ACCESSION NBR: 8003140383 DOC. DATE: 80/03/12 NOTARIZED: YES DOCKET #  
 FACIL: 50-269 Oconee Nuclear Station, Unit 1, Duke Power Co. 05000269  
 50-270 Oconee Nuclear Station, Unit 2, Duke Power Co. 05000270  
 50-287 Oconee Nuclear Station, Unit 3, Duke Power Co. 05000287

SUBJECT: Forwards response to NRC requests for info re non-nuclear instrumentation/integrated control sys failures. Corrective actions should preclude recurrence of event similar to Crystal River. No OL mods necessary.

Subject: Oconee Nuclear Station  
Docket Nos. 50-269, -270, -287

FIGURE 1  
OCONEE NUCLEAR STATION  
TYPICAL ICS/NNI AC SUPPLY

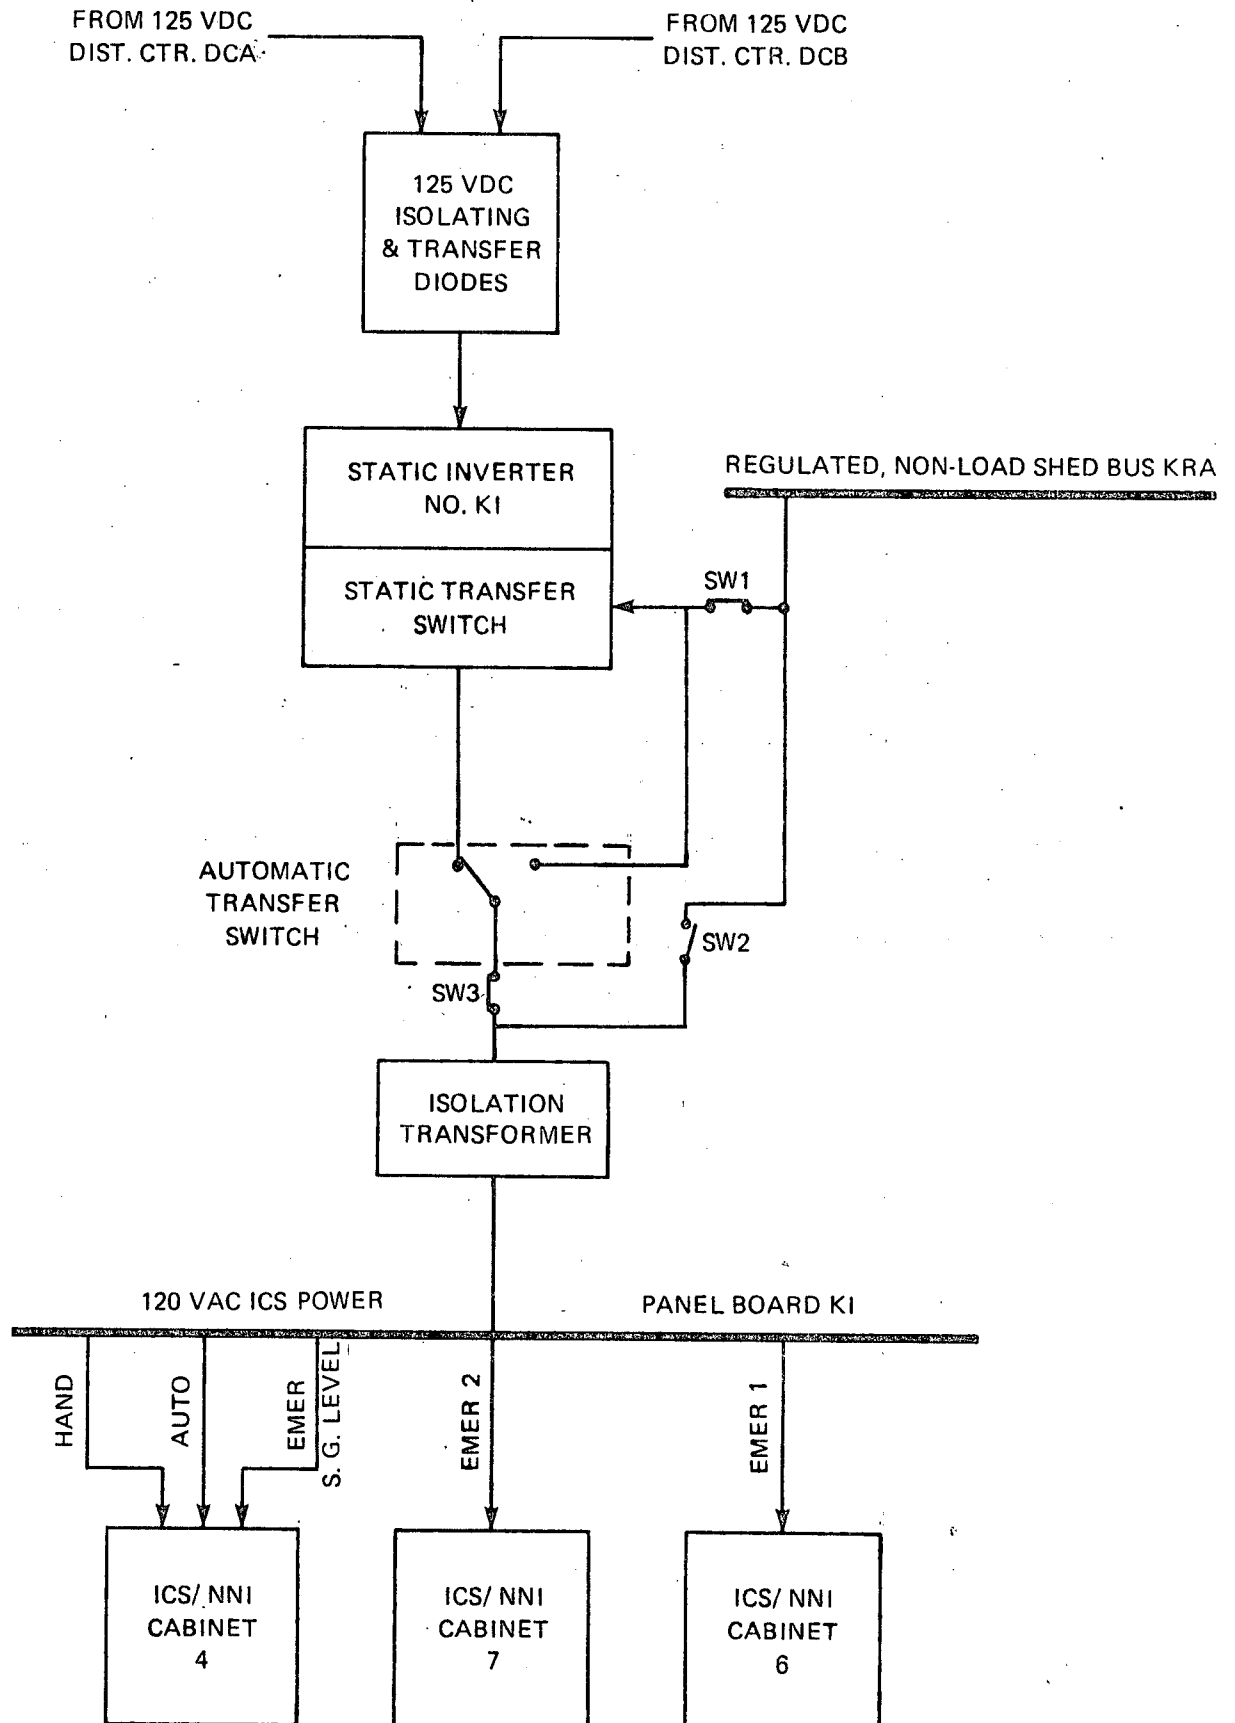
A. Improved Reliability of AC Supply to the Integrated Control System

The ICS/NNI system at Oconee is powered from a dedicated static inverter system which receives a DC input from the vital instrumentation and control batteries and a backup AC input from a regulated non-load shed bus. (Refer to the attached Figure 1.) On November 10, the static switch on the output of the inverter system failed preventing either the inverter source or the backup source from feeding the integrated control system. In this particular instance, power was restored by manually switching the backup source to panel 3KI. This was accomplished by the operator such that the ICS system was without power for approximately 2 1/2 minutes. To eliminate the need for a manual transfer and to improve the integrity of this AC supply, an automatic transfer switch has been added such that on an inverter or static switch failure, the inverter static switch system will be bypassed and regulated non-load shed power supplied to panel board 3KI through the automatic power transfer switch. This automatic transfer takes place in less than 1.2 seconds and eliminates the need for manual transfer.
